**PCN# : P57CAAB**  
**Issue Date : Jul. 20, 2015**

### **Information Only Notification**

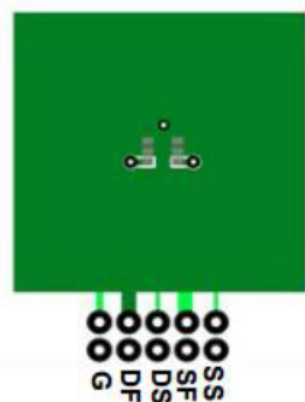
Description of Change (From) :  
Old thermal board images in datasheet (Page 2)

Description of Change (To) :  
New thermal board images in datasheet (Page 2)

Update thermal board images to match the board used in test
